APPLICATION NO.	FILING DATE	FIRST NAMED INVENTOR	ATTORNEY DOCKET NO.	CONFIRMATION NO.
09/19,842	08/09/1999	KLAUS-JUERGEN WESTERMANN	686	3637

Office Action Summary

DETAILED ACTION

FIG.1

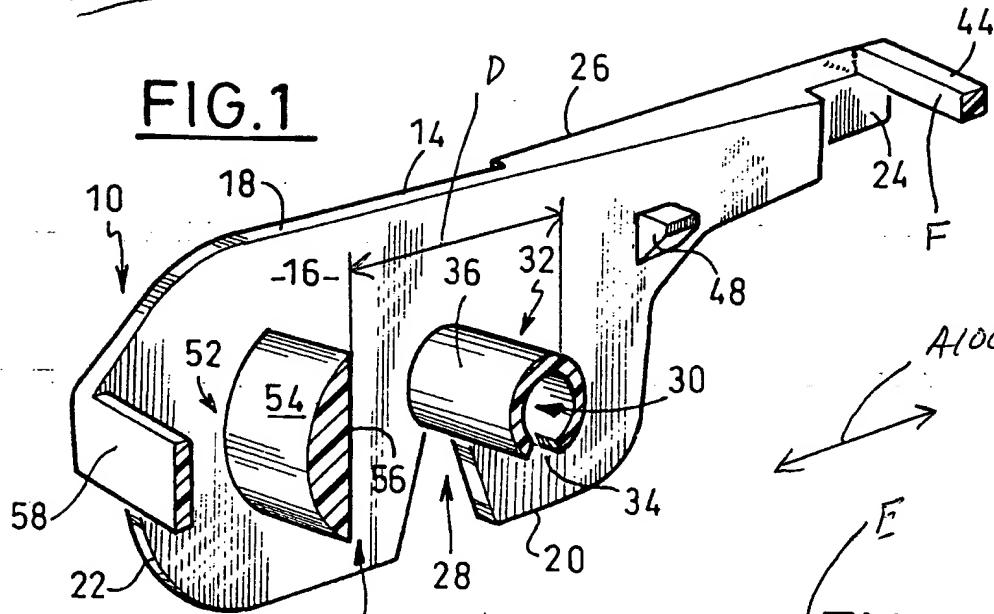
Regarding claim 1, the European patent '373 discloses in Figure 1 a bearing element **10** comprising a hub **32**, two side walls **14, 16**, contact faces **36, 56**, detent means **48** for holding the bearing element **10**, and lateral struts **44, 54**. The hub **32** is open over part of a circumference. The hub **32** connects the two side walls **14, 16**. The lateral struts **44, 54** extend in a longitudinal direction **A100** on both sides **A101** of the hub. The side walls **14, 16** have a smaller clearance **A1** and a larger clearance **A2**. Applicant is reminded that a recitation with respect to the manner in which a claimed apparatus is intended to be employed does not differentiate the claimed apparatus from a prior art apparatus satisfying the claimed structural limitations. *Ex parte Masham*, 2 USPQ2d 1647 (1987).

Regarding claim 4, a first lateral strut **54** has a contact face **56**. Figure 1 shows a second lateral strut **44** of the lateral struts **44, 54** is disposed at a distance from the first lateral strut **54**.

Regarding claim 5, the second lateral strut **44** has a flattened contact face **F** that is oriented towards the hub **32** (Fig. 1).
